Location:
25 Milford Drive

Request:
Site Plan Application

Hudson Planning Commission	SITE PLAN REVIEW
Case No. 2020-817	October 12, 2020

IMPROVEMENT PLANS FOR 25-33 MILFORD DRIVE

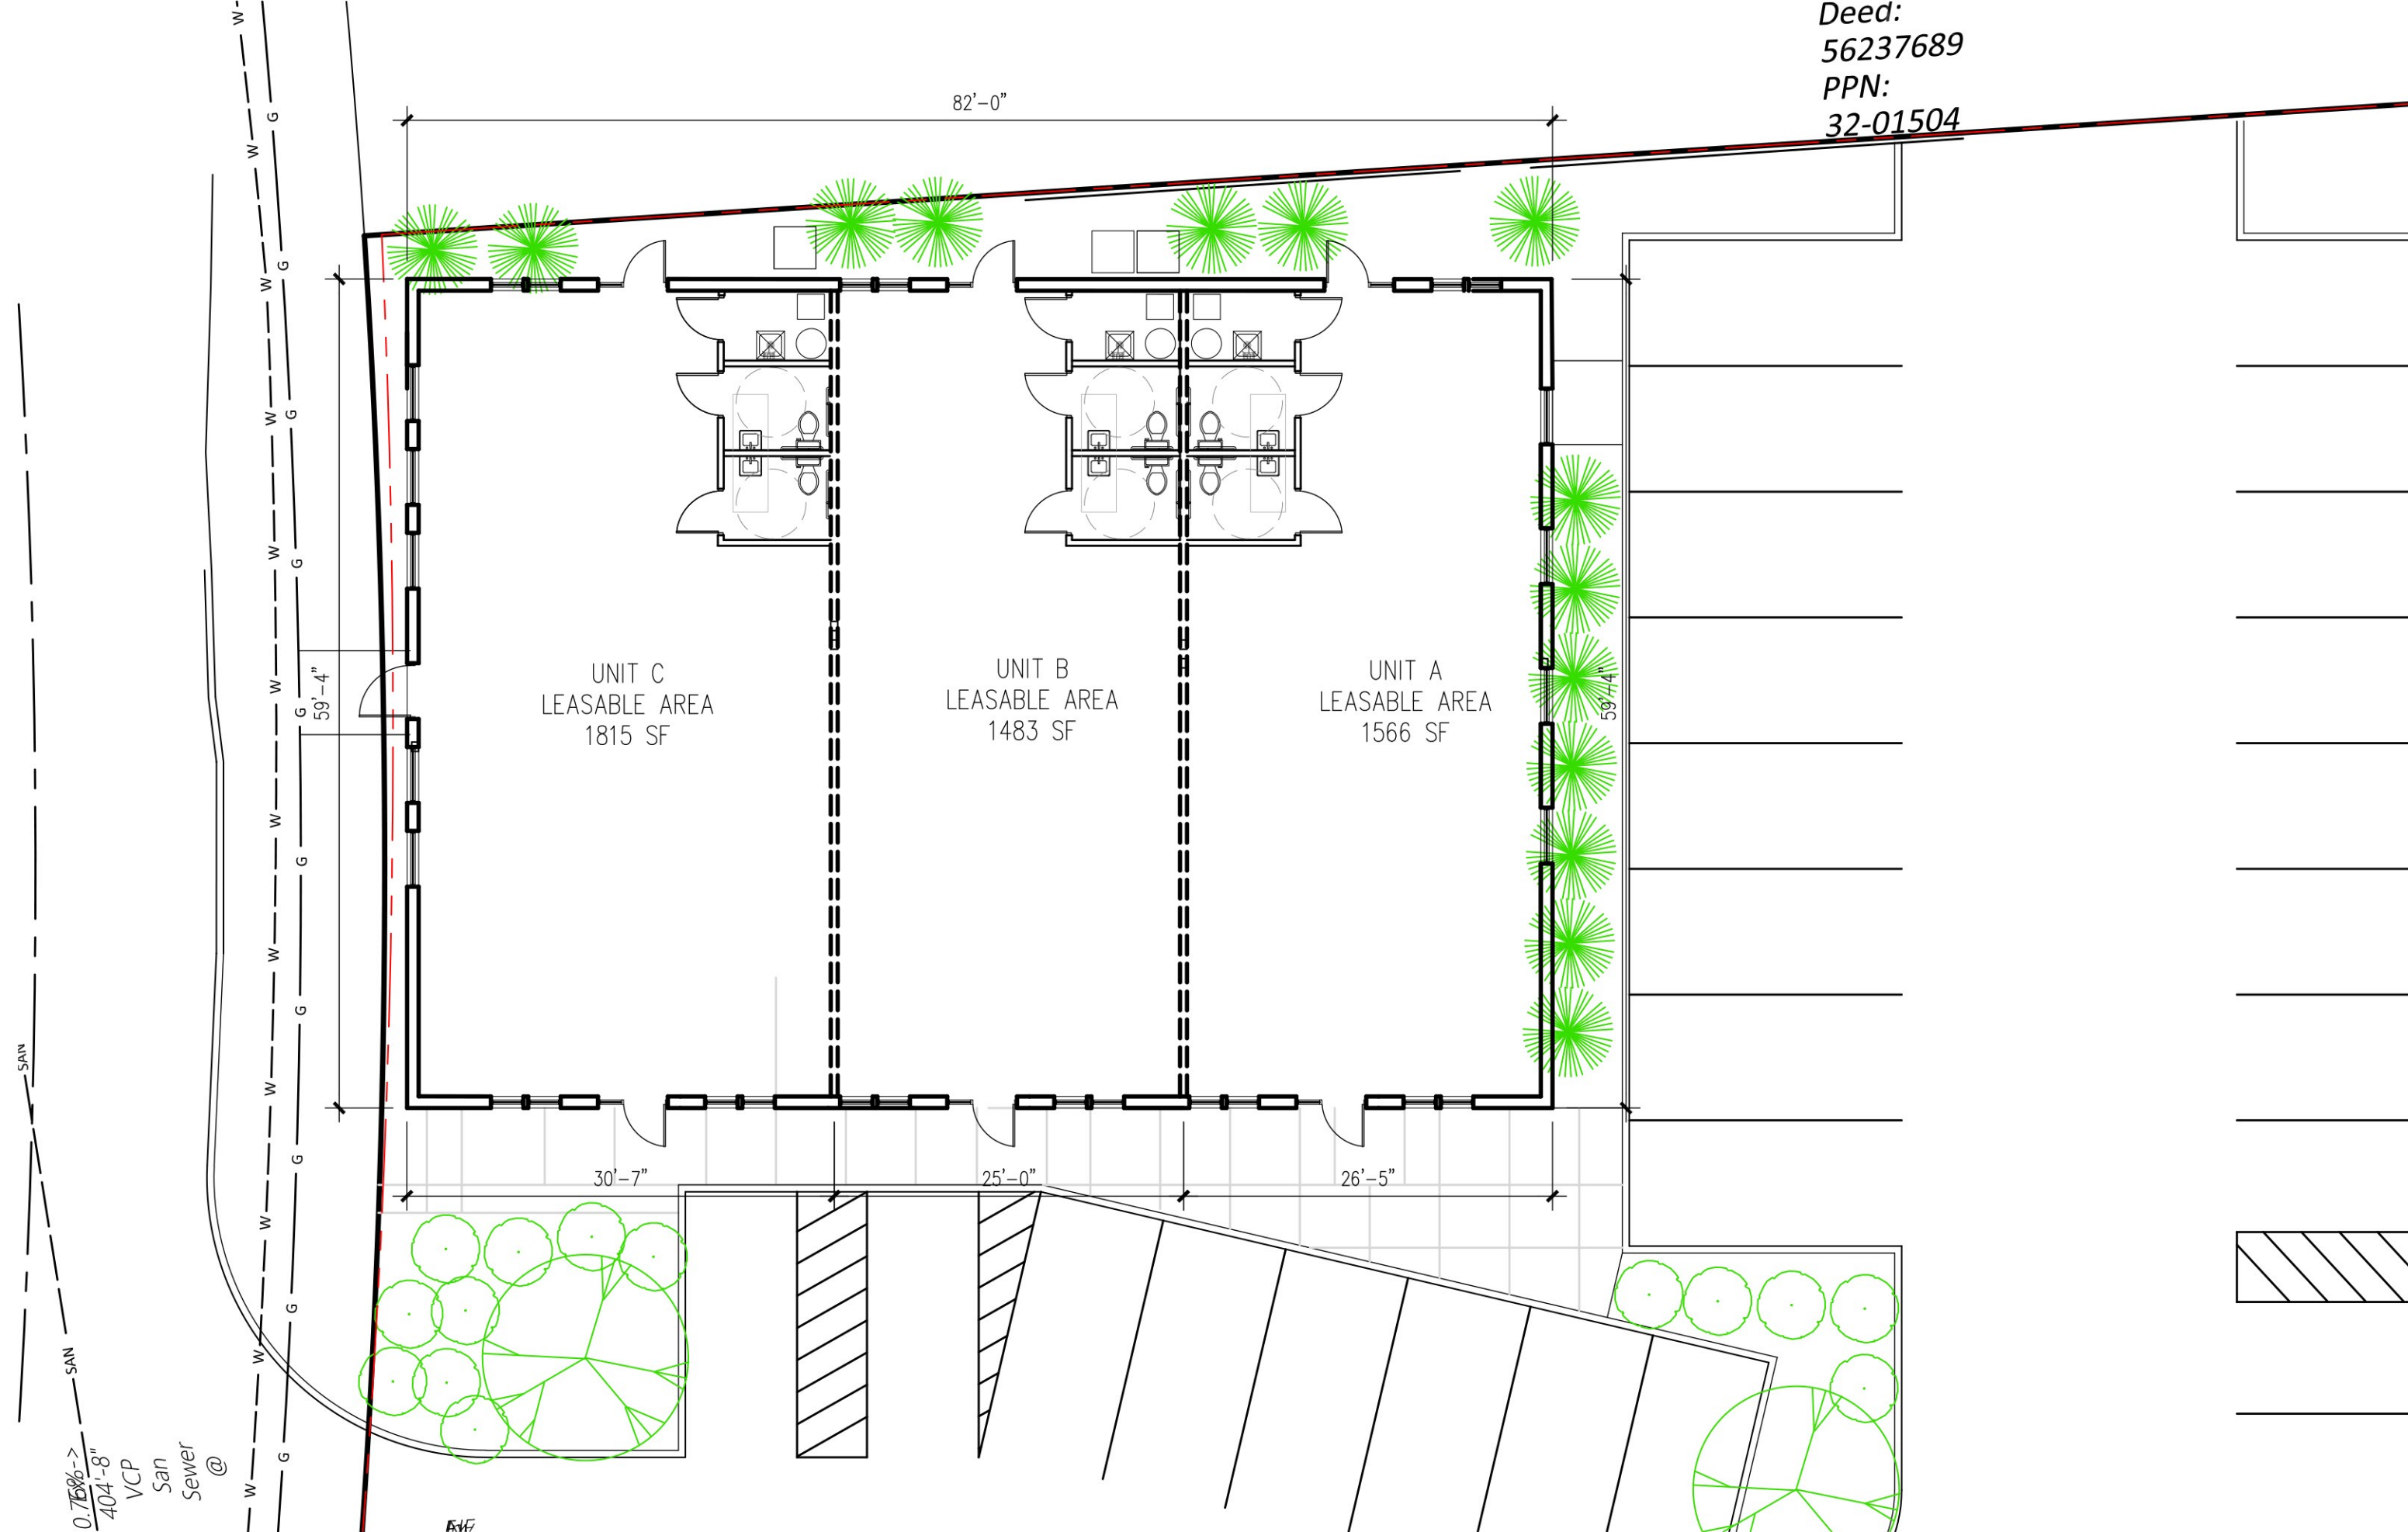
Landscaping The LDC requires parking lots to have perimeter landscaping of a minimum width of 5 feet. Staff notes the proposed turnaround at the northernmost portion of the parking lot would have a setback of 1 foot.

Furthermore, the perimeter landscaped area must contain sufficient plant material that will achieve an effective, opaque screen of a height of at least three feet within two years of installation. Additional landscaping should be added along the northern property line to meet this requirement.

Staff recommends reducing the overall parking count to provide space for landscaping along this northern boundary.
